BRIDGES
MAR. - OCT. 1944

01 28 OCT 1944
Subject :- Bridge ALBIGNA, Route.1.

SUBJECT: Completion of Permanent Bridge by ACC Contractors.

Subject: Bridge Plans

Subject: BRIDGE LOADINGS.

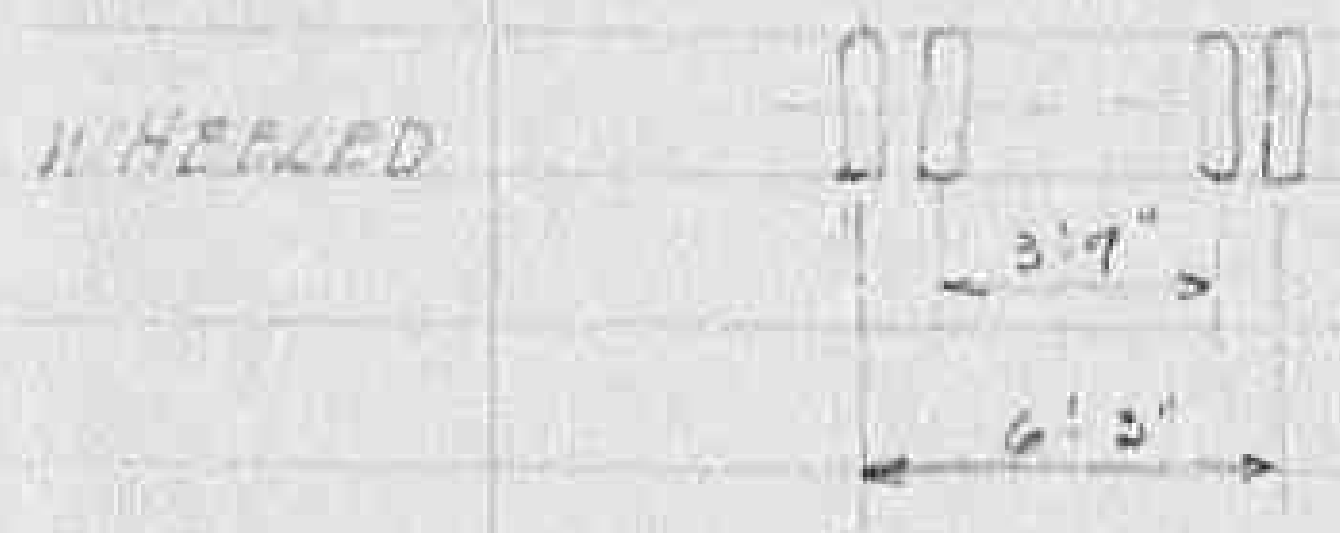
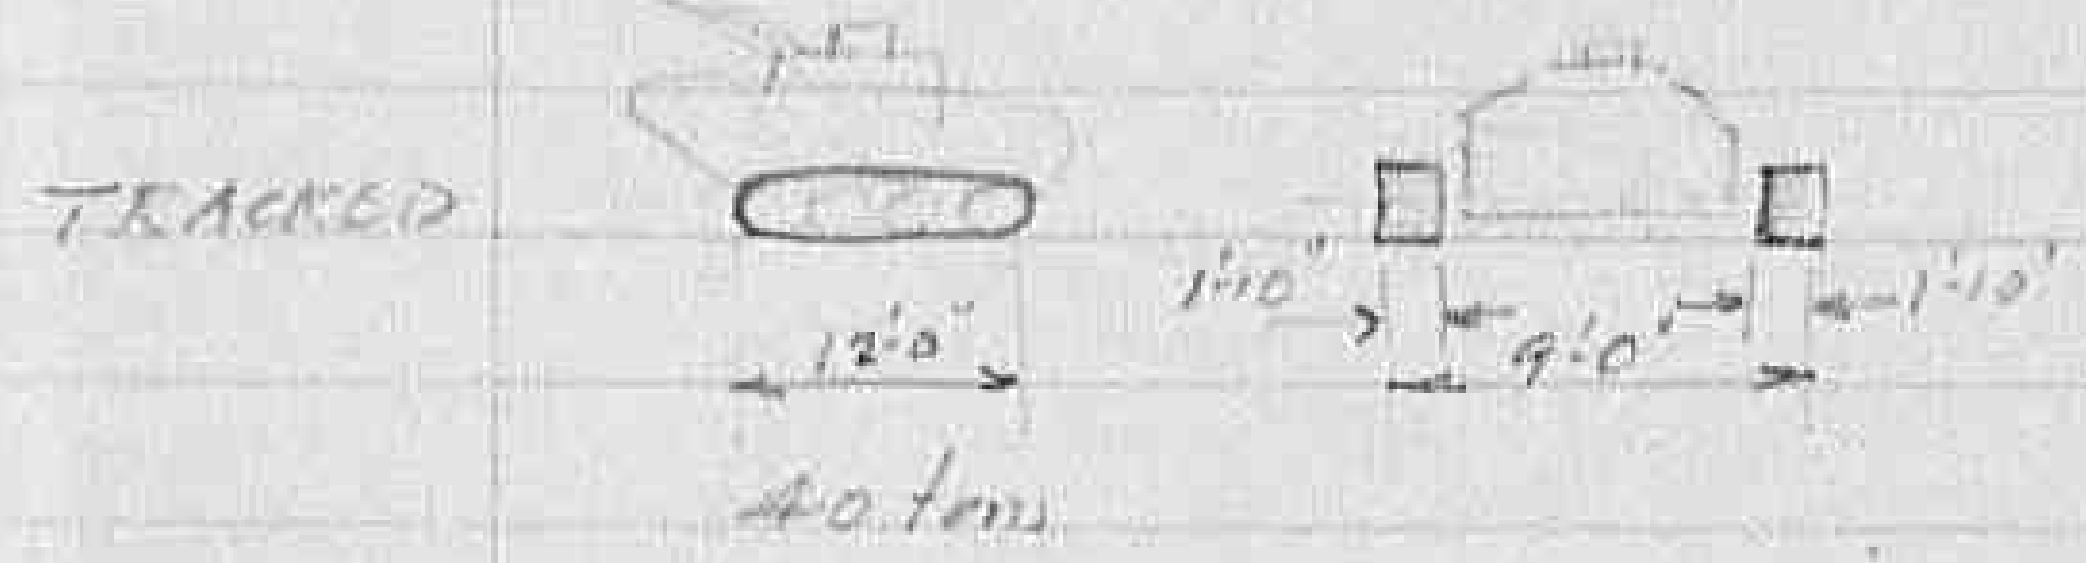
Herewith is a diagram of a Class 40 Load.

Max Load 12.5 tons per axle.
25. tons on 2 Axles
4'-0" cts.

Max load per tire 6.25 tons

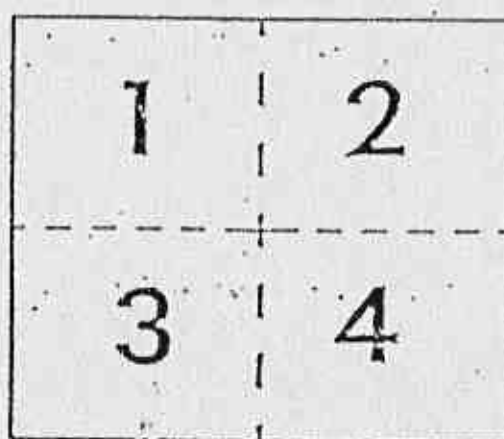
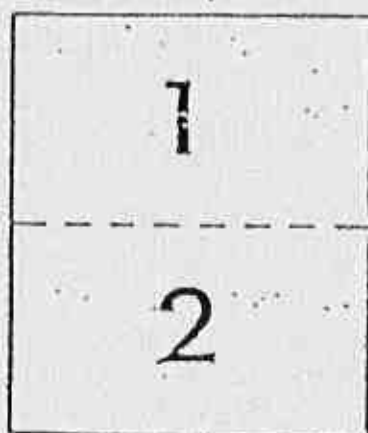
That a through truss bridge be built of either steel, concrete, or timber, depending on material available. The trusses could be easily placed on either side of present Bailey trusses without interference to traffic, and decking need present no difficulty. If necessary Bailey Bridge can be jacked up to provide more clearance, when placing new deck below.

The length of span, about 75' 0", is ideal for such construction, the high center pier is eliminated and the only masonry reconstruction required is the building up of the present piers from the springing to the deck line to take vertical reactions. This can be done without interfering with traffic.

I suggest that A.A.S.S. at Caserta be contacted to determine how they propose to tackle the job, but strongly recommend that ~~the~~ bridge plan be brought to their attention.
